Application of ModWash, LLC c/o Battle Law P.C. for a request to modify zoning conditions to remove condition #1 pursuant to CZ-06-1241, restricting the use of the property to office and retail uses to allow a car wash in the C-1 (Local Commercial) zoning district, at 1849 Lawrenceville Highway.

PETITION NO: D6-2022-1998 CZ-22-1245934

STAFF ANALYSIS

Case No.: CZ-22-1245934 **Agenda #:** D6

DRAWING TITLES	
SITE PLAN	
PROJECT NAME:	MODWASH 1849 LAWRENCEVILLE HWY, DECATUR, GEORGIA
CLIENT:	HUTTON 738 CHERRY STREET, CHATTANOOGA, TENNESSEE 37402

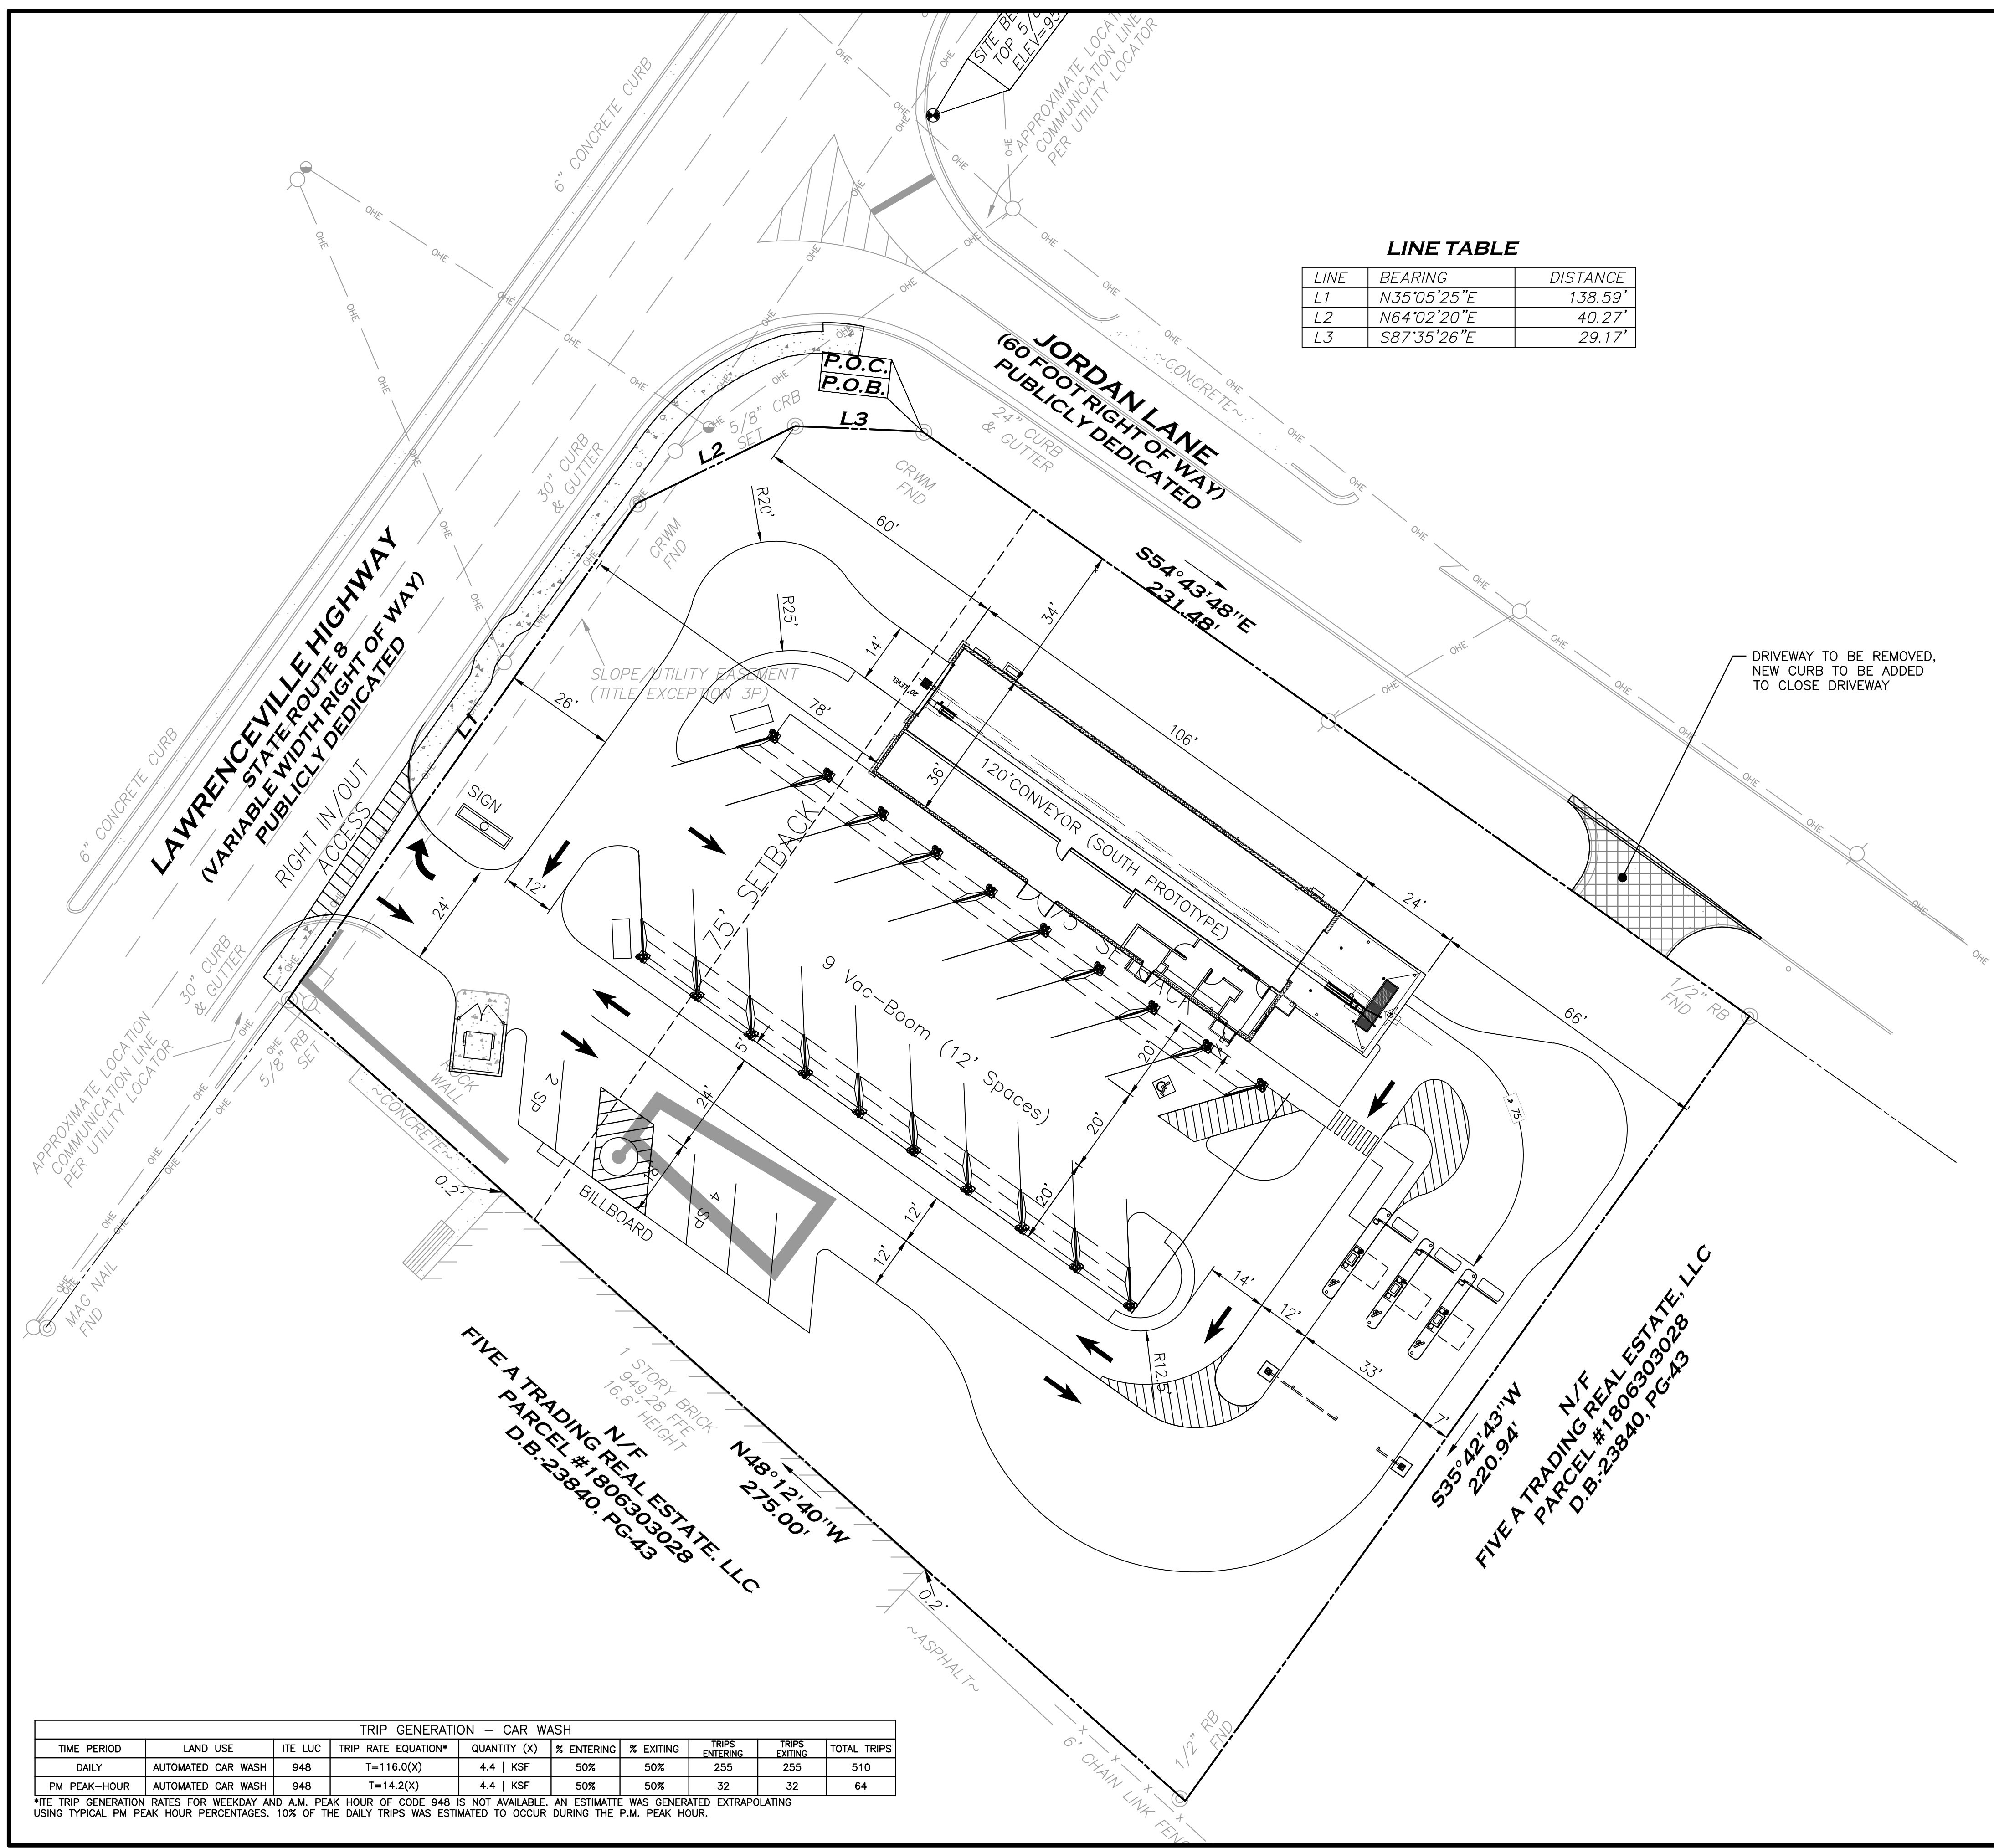
Conceptual plan doesn't indicate the location of the stormwater management facility. Location of stormwater management shall be shown or compliance with the County stormwater management regulations shall be explained.

Runoff Reduction Volume shall be provided, unless technical justification is provided in regard to the unfeasibility. Strongly recommend investigating the site and identify location where RRv can be provided and re-design/revise the layout to comply with the RRv requirement.
